Environmental Assessment Errata Sheet

Loop 375 (Transmountain Road) from I-10 to 0.479 mile East of the Tom Mays Unit of the Franklin Mountains State Park Entrance

CSJ 2552-01-033

August 9, 2011

MATCH LINE B

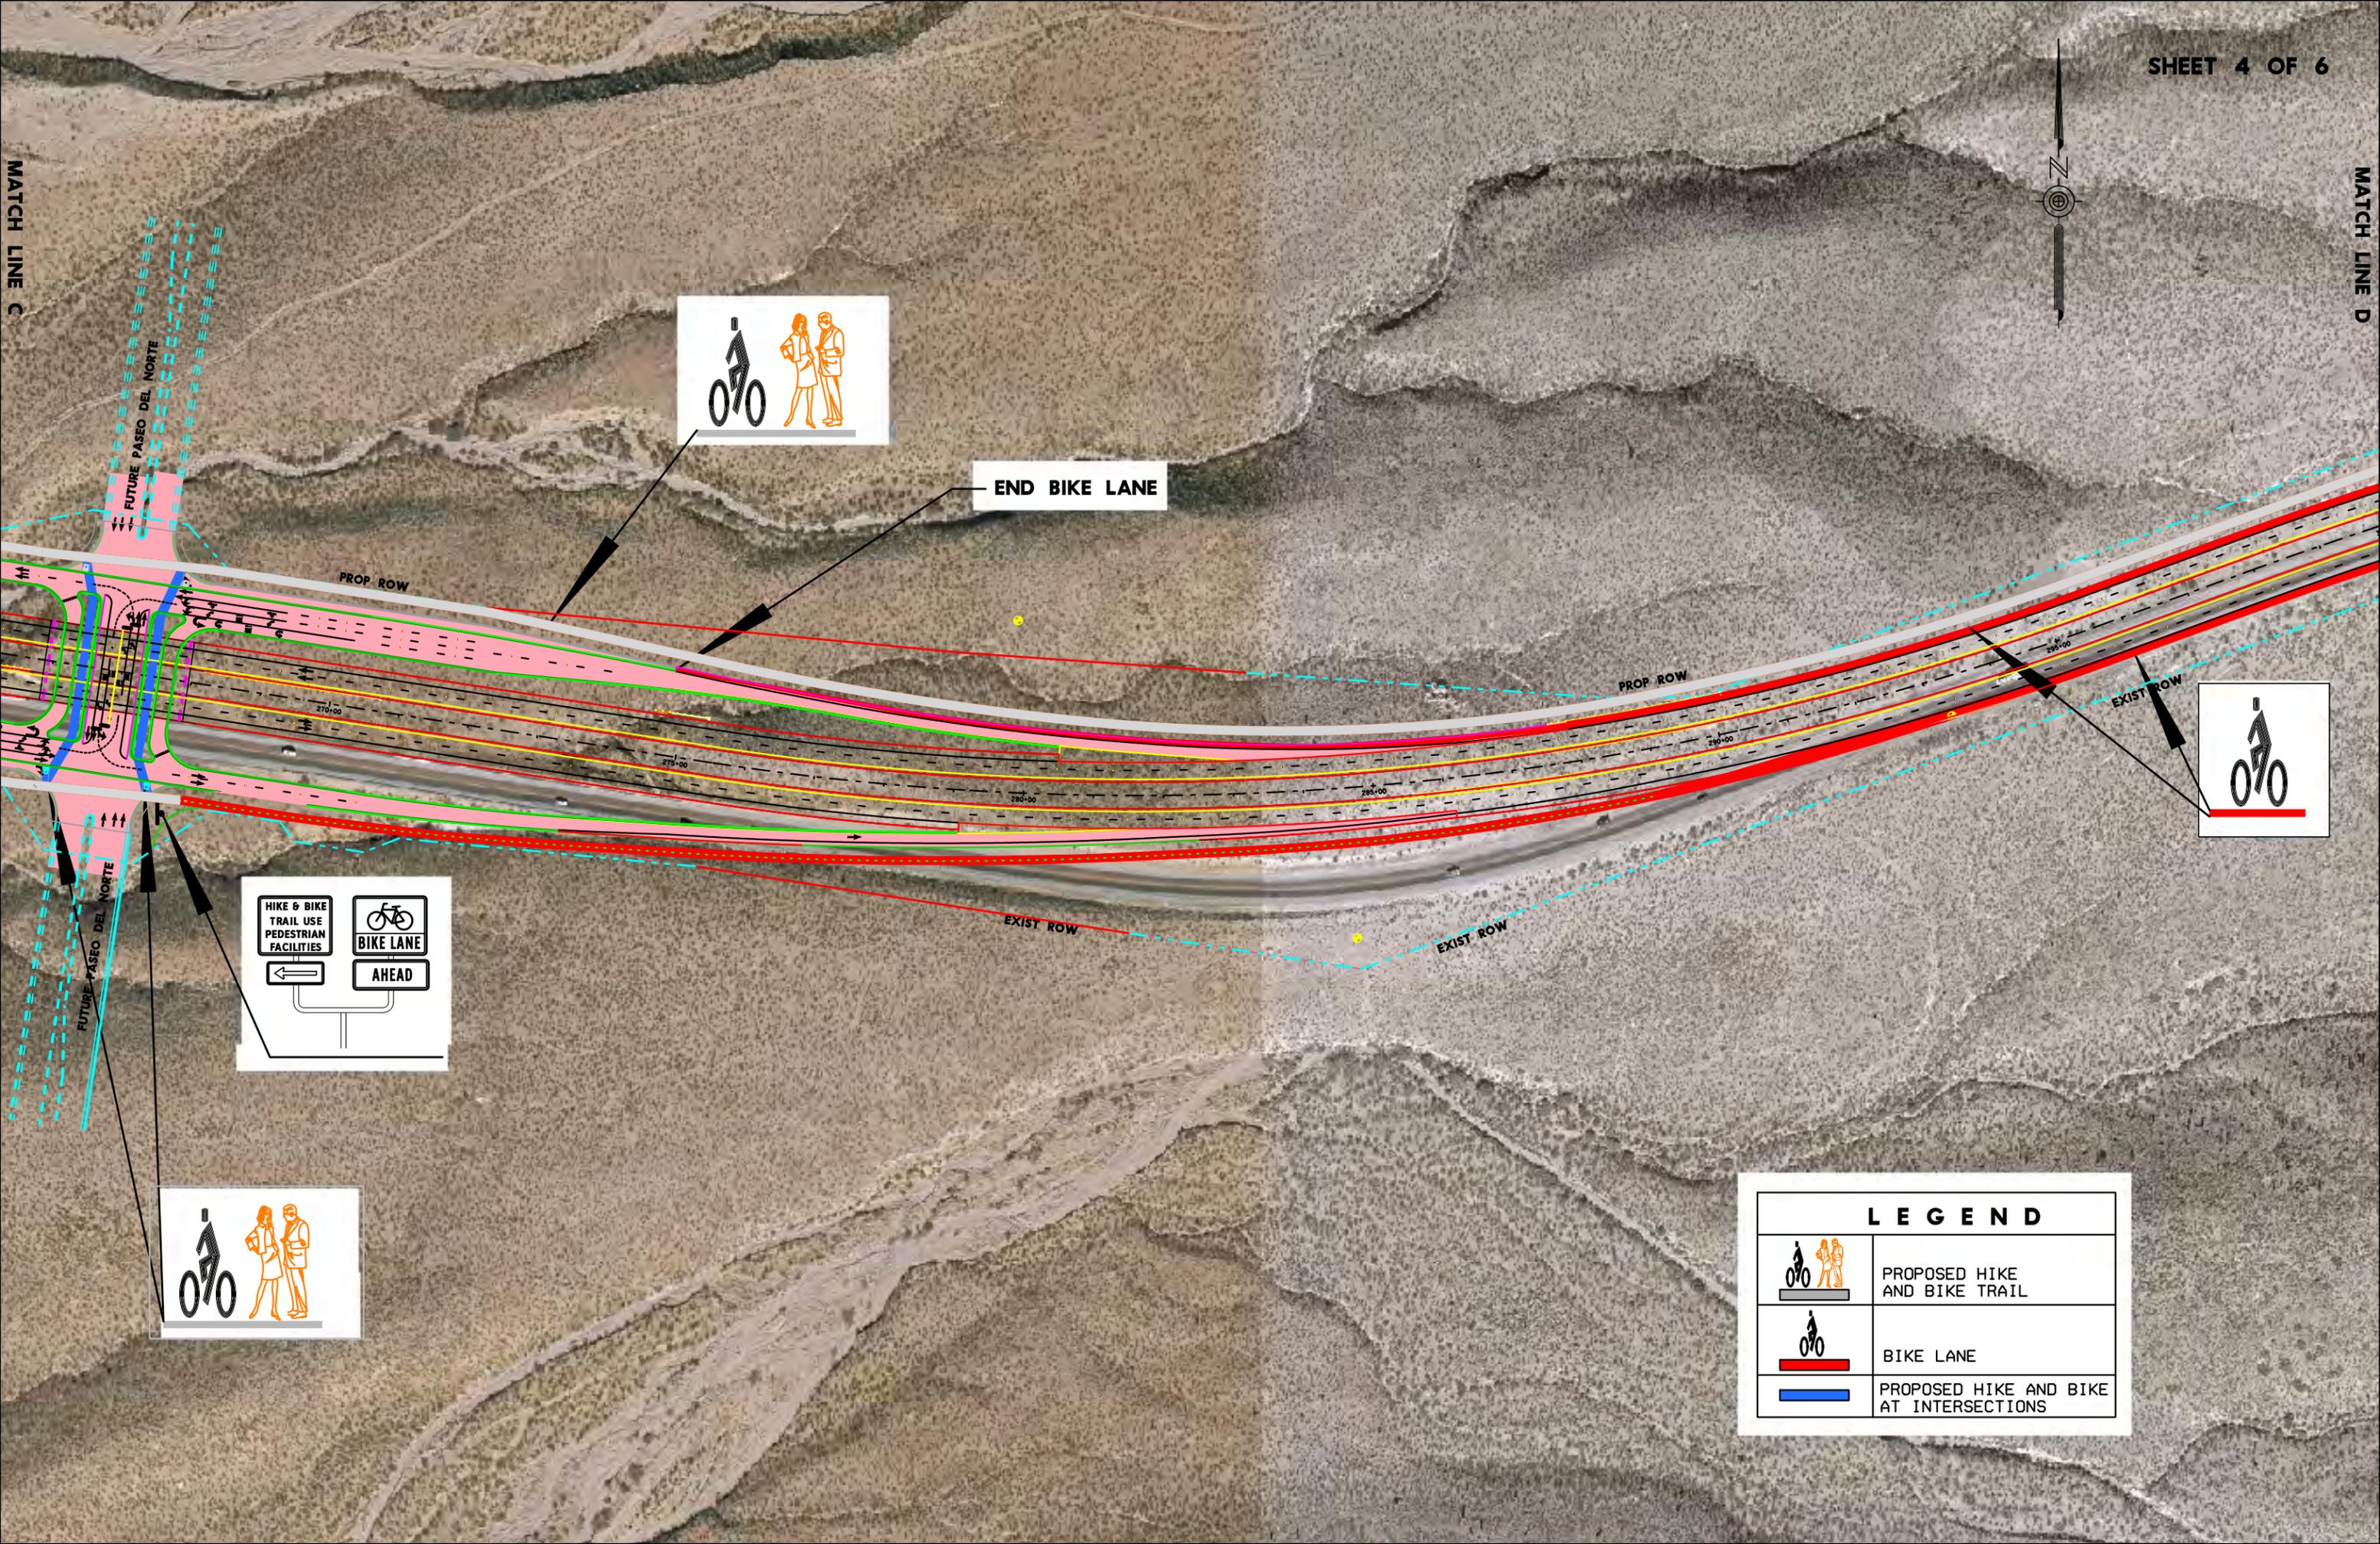
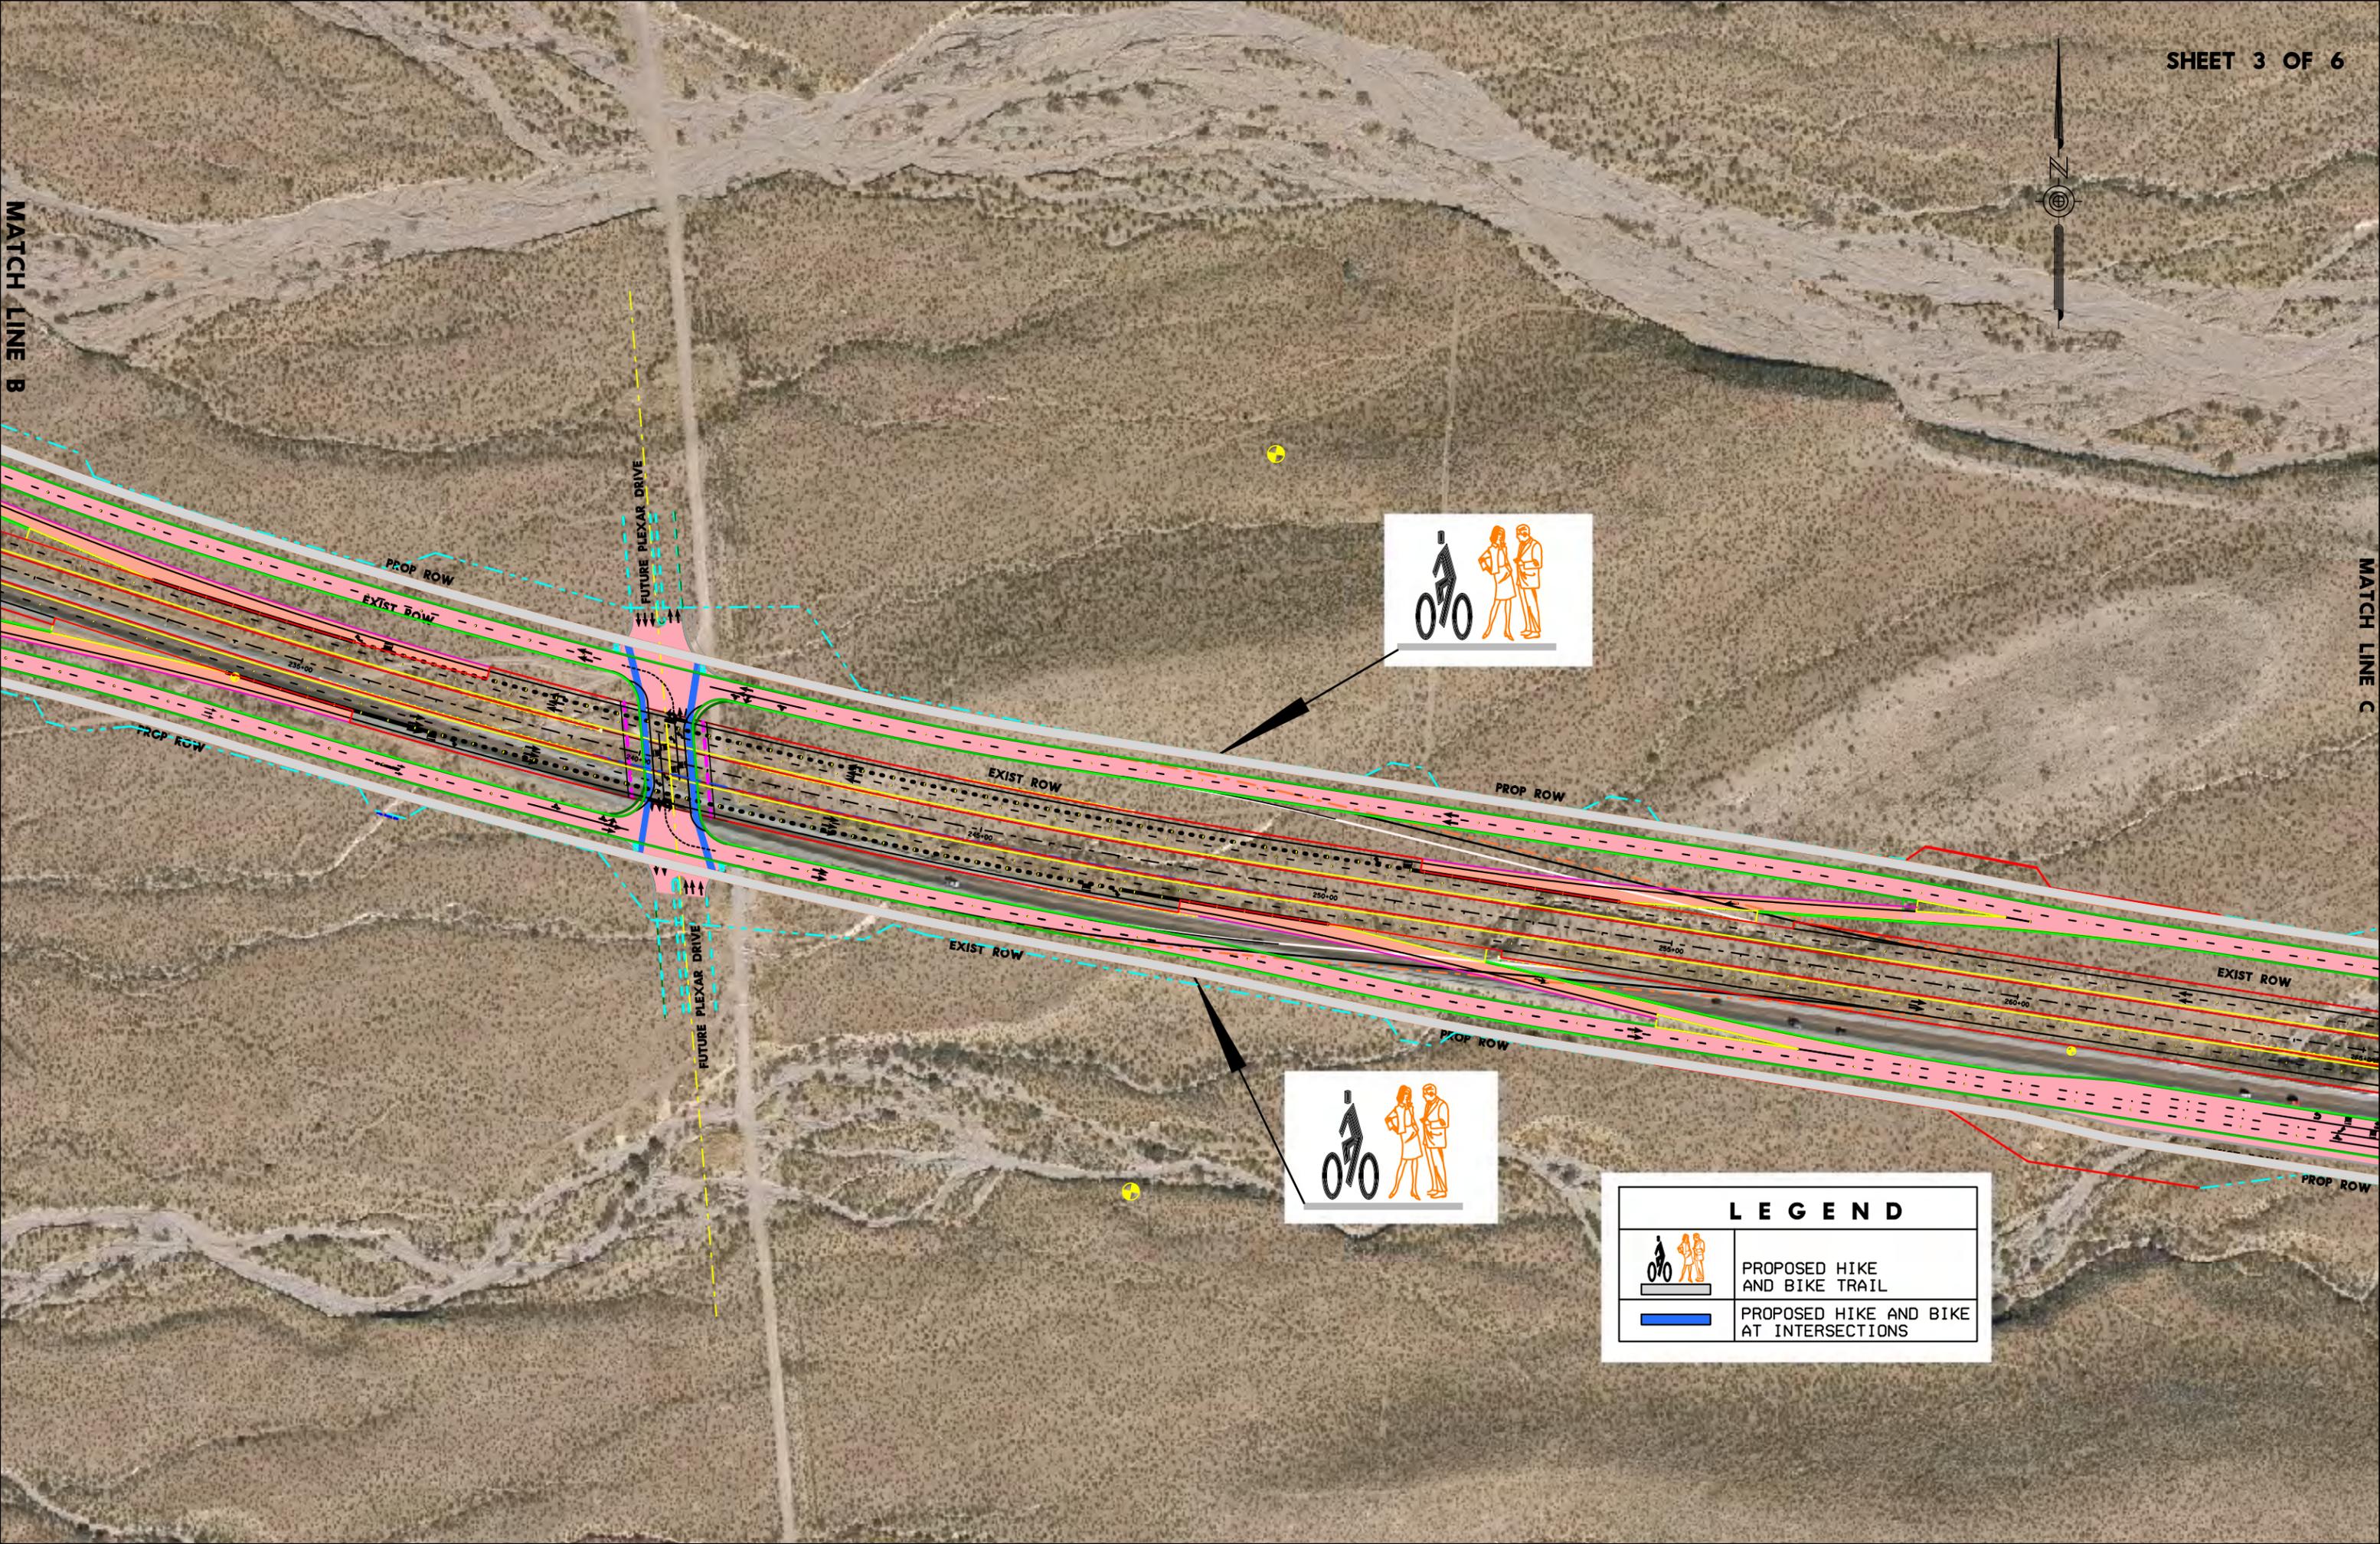
23. Page 119, Section 3.15: the following statement is added as an additional bullet regarding the proposed hike-and-bike trail:

***TPWD Comment 3:** The February 2011 EA (Page 25 and Figure 4.4) retains the south side hike and bike lane terminus at the frontage road. However, the February 2011 EA (Page 25) commits to encouraging foot and bicycle traffic to cross to the north side of Loop 375 at the Paseo Del Norte Road intersection to continue eastbound towards the Franklin Mountains State Park.*

“TxDOT will construct a hike-and-bike trail north of LP 375 inside existing highway right of way from the proposed Paseo Del Norte Drive and the FMSP driveway. This portion of the hike-and-bike trail would connect with the hike-and-bike trails proposed for construction between I 10 and the future Paseo Del Norte Drive. The hike-and-bike trails located between I-10 and the future Paseo Del Norte Drive would have the option to access the highway shoulders of LP 375 east of the future Paseo Del Norte Drive, or to use the proposed hike-and-bike trail along the northerly right of way line of LP 375 to access the driveway to the Tom Mays Unit. Pedestrian and bicycle traffic would be encouraged to cross LP 375 at the Paseo Del Norte Road intersection using sidewalks and five-foot-wide dedicated bicycle lane, and continue eastbound towards the FMSP Entrance on the north side of the road.”

bicycle lane, and continue eastbound towards the FMSP Entrance on the north side of the road. A diagram noting the hike-and-bike trail system planned for the proposed project is attached to this letter for reference.

TxDOT Response to Comment 3: TxDOT recognizes the comment from TPWD and has designed signing for the proposed project to encourage pedestrian and bicycle traffic that uses the southerly hike-and-bike trail to use the northerly hike-and-bike trail in order to access the driveway to the Tom Mays Unit. Bicycle traffic that wishes to proceed eastbound along Loop 375 will continue to have the option to use the eastbound shoulder of Loop 375 east of the future Paseo Del Norte Drive.
